PRODUCT CHANGE NOTIFICATION

Date: June 11, 2020
PCN: PCN LEDIL 164

Subject: Material change for STRADA- and HB-IP-2X6 lens gaskets

GASKET DESIGN CHANGES

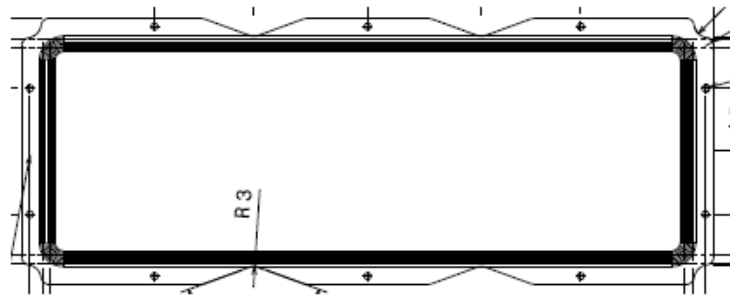
Changes: The raw material for STRADA- and HB-IP-2X6 gasket has been changed from Dow Corning RBB-2030 to Shinetsu-CHN-ROLL-40U.

In addition, the gasket design has been simplified by removing some excess material.

All the lens mechanical dimensions, optical performance and IP/IK ratings remains the same.
